5.6 Through site link

APPENDIX A MODIFICATION REQUEST

APPENDIX C RECOMMENDED MODIFYING INSTRUMENT

Figure 8: Proposed ground floor layout illustrating proposed angled site link

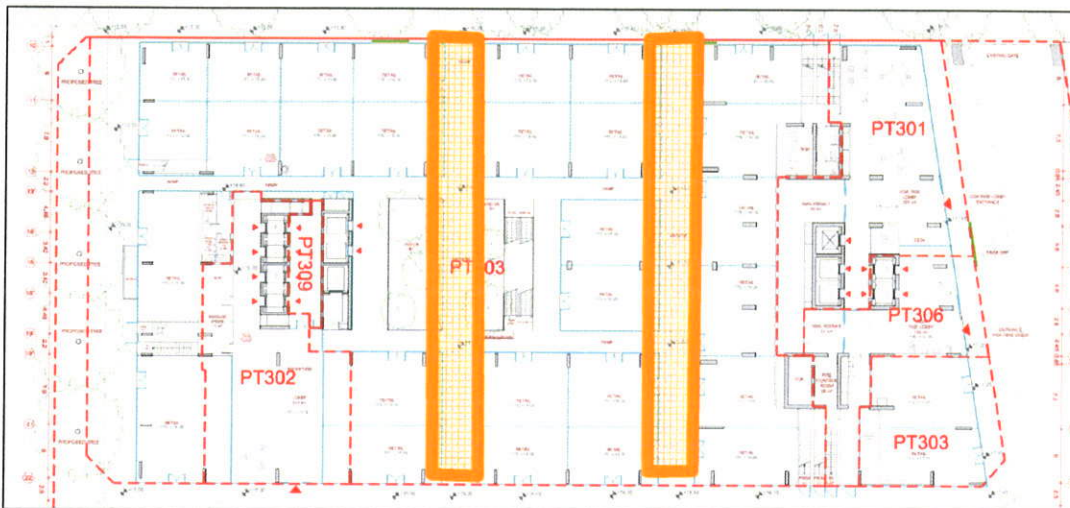
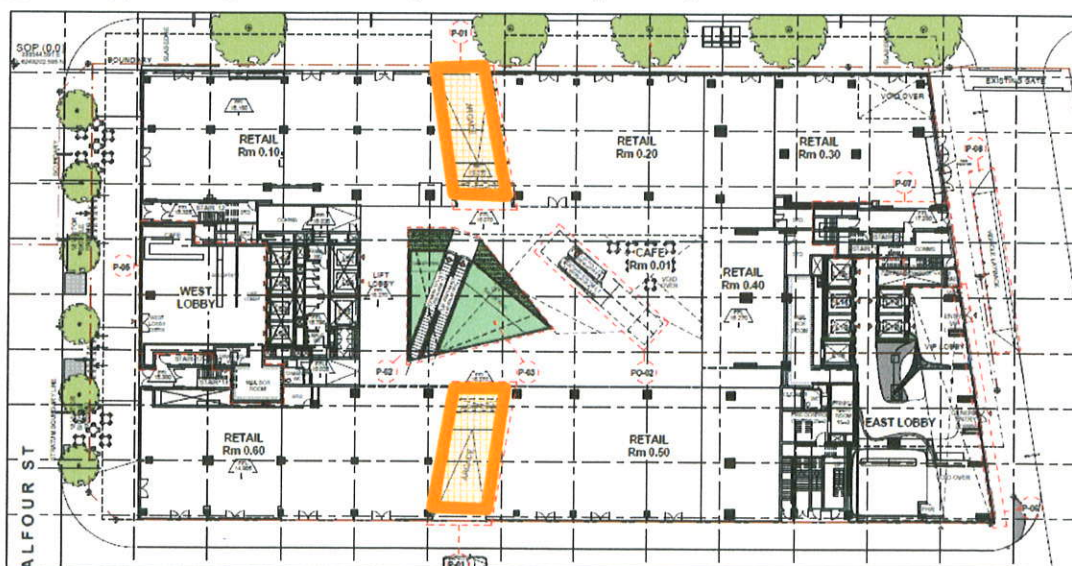
Amendments to the approved ground floor public access through site links are proposed by modifying the approved double access points into a single 6 metre access point (**Figure 6 and 7**). The Concept Plan approved 2 pedestrian links through the building, one provided as a straight through link while the other includes a common area in the middle of the site.

The modification seeks to amend the scheme by proposing an angled entrance from Broadway and Tooth Avenue that opens up to escalators and associated landscaping provided in the middle of the access points. Council raised concerns with the position of the proposed link in the through site link and the proposed supermarket escalator and associated vegetation, in particular, obstructing the through site link both visually and from an access perspective. Concerns were also raised with utilising the through site link as an entry to the supermarket and recommended that a 6 metre wide path of travel should be maintained from north to south.

The Department considers that the design is acceptable and does not reduce the success of the through site link as a pedestrian pathway, particularly with the increased width of the paths. Access to the below ground supermarket and piazza area and the above ground retail / food court / gym is maintained. A reduction to one through site link is also considered suitable (as supported by Council), with the modified design considered to be consistent with the built form within the locality.
